RE: PLANNING REF SD 21A/0346 ADDITIONAL INFORMATION RESPONSE

In response to the Decision Order Number: 0242 for Planning Reference No. SD 21A/0346 dated 22nd February 2022 we hereby submit our responses to the requests for additional information on the Water Services related items only:-

Figure 1 Existing Site Layout

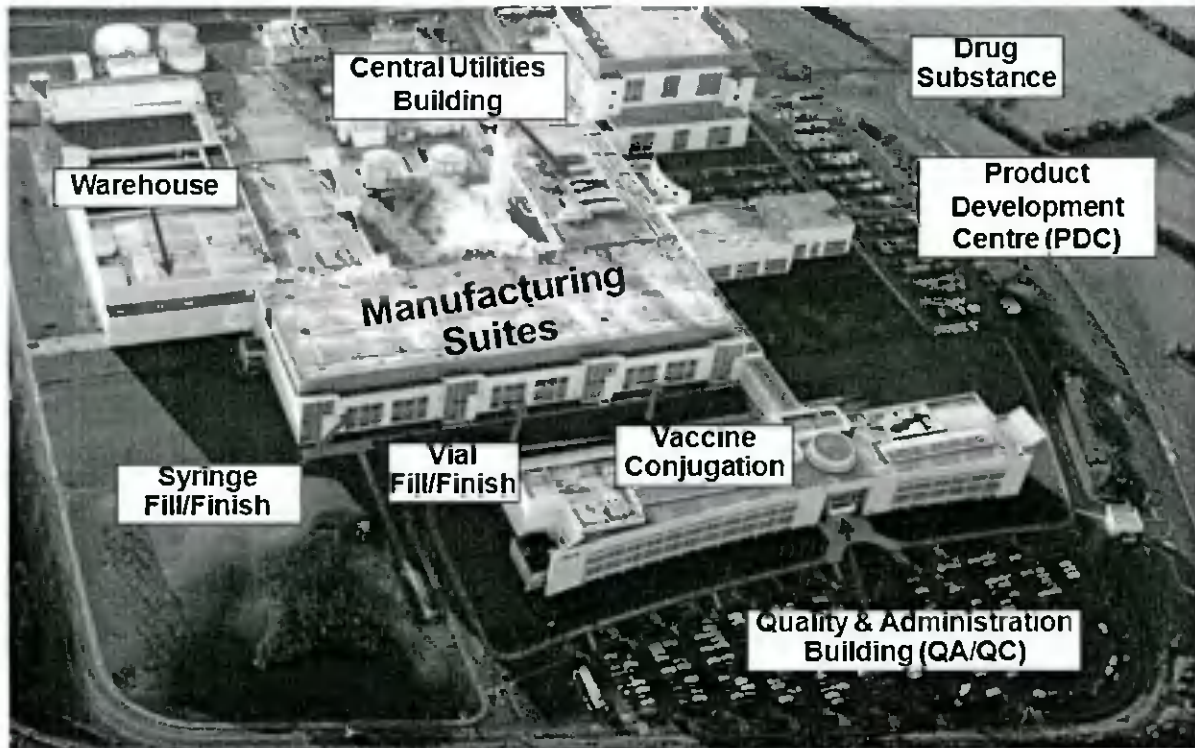
3.(i) The applicant is requested to submit a report showing surface water attenuation calculations for proposed development. The Applicant is requested to detail what attenuation in m3 is required and what is provided in m3. Include the site area, the area of different surface types such as, green roofs, buildings, roads, permeable paving, green areas in m2 and their respective run off coefficients. Also show the SAAR (Standard Annual Average Rainfall) value and site specific Met Eireann rain fall data. Show what surface water attenuation is provided and what is required in m3 for proposed development. All surface water should be attenuated by means of SuDs (Sustainable Drainage Systems) where possible. The applicant must include SuDs as part of their development. Examples of such SuDs features are as follows but not limited to.

If SuDs does not provide sufficient surface water attenuation, the Applicant is requested to show on a drawing how surface water will be attenuated for the proposed development. The drawing must show that surface water and foul water drainage systems are draining to separate pipe networks.

The existing Pfizer Pharmaceutical Campus site characteristics comprises a mix of roofs, roads, hardstanding and soft landscaping. Refer to Figure 1 below for an indication of the site existing layout and finished surfaces.

Existing Catchment Characteristics			
Pfizer Grange Castle	Area (m ²)	Runoff Coefficient	Effective Area (m ²)
Roofs - (Draining to gullies)	50,810	1.00	50810.0
Roads - (Draining to gullies)	16,250	0.80	13000.0
Carparking - (Draining to gullies)	36,090	0.80	28872.0
Permeable Paving	5,480	0.70	3836.0
Concrete Footpaths/Yards - (Draining to gullies)	22,580	0.80	18064.0
Contractors Stone Compound (Clause 804 Assumed)	62,820	0.50	31410.0
Parks/Open Space	155,970	0.30	46791.0
